Service Bulletin

Bulletin No.: 02-06-04-037D

Subject: DTC P0446 (Restricted/Blocked EVAP Vent Path) Set, Check Engine Light On (Replace Evaporative Emission (EVAP) Vent Valve Solenoid Assembly and Add/Relocate Filter Box Using Service Kit)

Models: 1999–2007 Chevrolet Silverado (Classic) Models
1999–2007 GMC Sierra (Classic) Models
2007–2008 Chevrolet Silverado Models
2007–2008 GMC Sierra Models

1848436

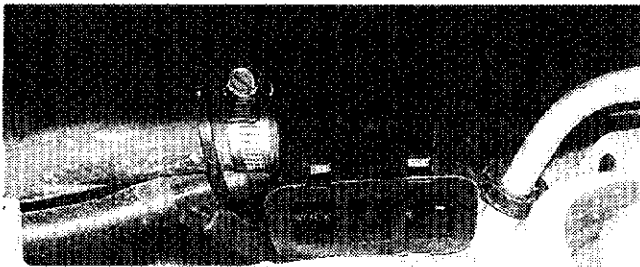
1. Raise the vehicle. Suitably support the vehicle.
2. Disconnect the EVAP canister vent valve electrical connector, if equipped.
3. Disengage the two vent valve pipe clips securing the pipe to the underbody. Remove the clips from the underbody and discard.
4. Disconnect the vent valve pipe at the EVAP canister.

5. Remove and retain the EVAP canister vent valve bracket mounting bolt.
6. Remove the complete EVAP canister vent valve assembly with bracket attached and discard.

Important: The new canister vent valve will be installed in a new location, outside of the frame.

7. Position and secure the new valve assembly to the frame bracket on the outside of the frame using the existing hole and mounting bolt.

Crew Cab Short Box Shown Below, Other Configurations Similar

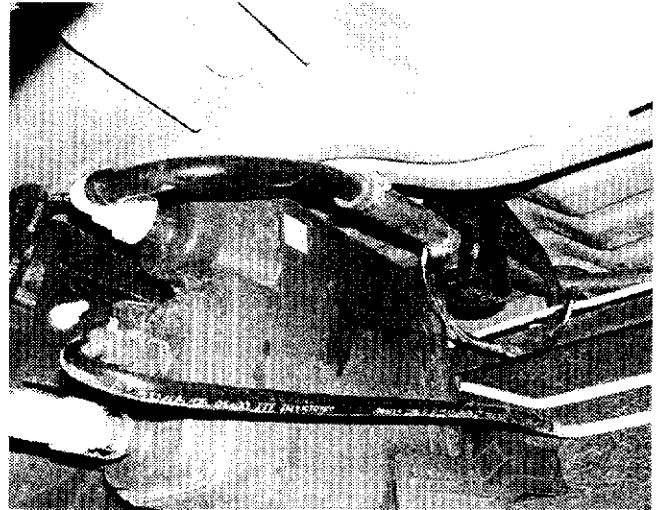
1. Raise the vehicle. Suitably support the vehicle.
2. Disconnect the EVAP canister vent valve electrical connector.
3. Disconnect the canister pipe from the vent valve.
4. Push in the retainer and remove the existing canister vent valve from the fuel tank clip or mounting bracket. Discard the old valve.
5. Cut back the existing canister pipe approximately 51 mm (2 in) to remove the quick connect end.

6. Install the new canister vent valve to the fuel tank clip or mounting bracket.
7. Cut bulk 5/8" heater hose to a length of approximately 76 mm (3 in). Install the hose between the vent valve and the canister pipe and secure using clamps.
8. Attach bulk 5/8" heater hose to the vent valve port and secure using a clamp. Run a length as needed along the frame rail routing to the area above the transmission.
9. Cut the hose to determined length and install the supplied filter box. Secure using a clamp.
10. Remove the transmission support and lower the transmission assembly as necessary to allow for access to the new filter box location.

2500 Crew Cab Short Box Shown Below, Other Configurations Similar

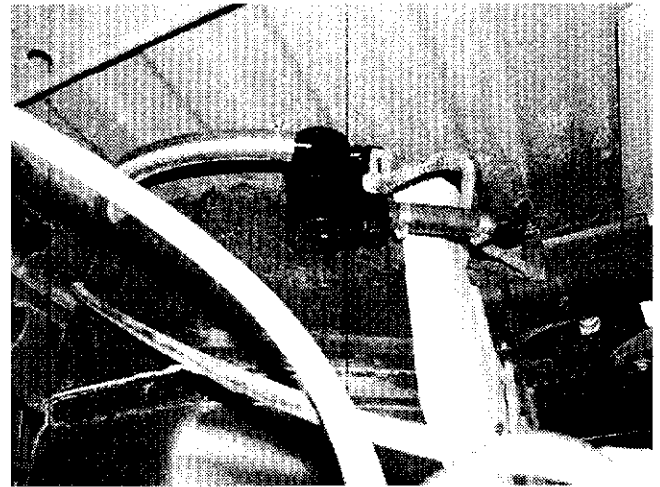
1. Raise the vehicle. Suitably support the vehicle.
2. Disconnect the EVAP canister vent valve electrical connector.
3. Disconnect the vent valve pipe quick connect from the canister.
4. Either cut the existing valve vent pipe and leave the remaining section of pipe in the vehicle or remove along with the valve.
5. Push in the retainer and remove the existing canister vent valve from the fuel tank clip or mounting bracket.
6. Cut back the existing canister pipe approximately 51 mm (2 in) and retain the pipe for use with new valve.
7. Connect the canister pipe quick connect to the canister.

8. Install the new canister vent valve to the fuel tank clip or mounting bracket.
9. Cut bulk 5/8" heater hose to a length of approximately 76 mm (3 in). Install the hose between the vent valve and the canister pipe and secure using clamps.
10. Attach bulk 5/8" heater hose to the vent valve port and secure using a clamp. Run a length as needed along the frame rail routing to the passenger side area above the transmission.
11. Cut the hose to determined length and install the supplied filter box. Secure using a clamp.
12. Remove the transmission heat shield, if necessary.
13. Remove the transmission support and lower the transmission assembly as necessary to allow for access to the new filter box location.

2094032

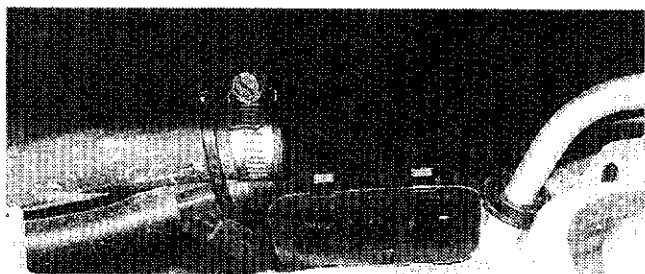
14. Secure the filter box to the transmission vent hose just forward of the hose tee-section using a tie strap. DO NOT pinch or restrict the transmission vent hose. The filter box opening should be pointing downward.
15. Raise the transmission and reinstall the transmission support.
16. Reinstall the transmission heat shield.
17. Connect the EVAP canister vent valve electrical connector.
18. Tie strap the hose as needed along the frame rail in order to keep the hose away from pinch-points and heat sources.
19. Lower the vehicle.
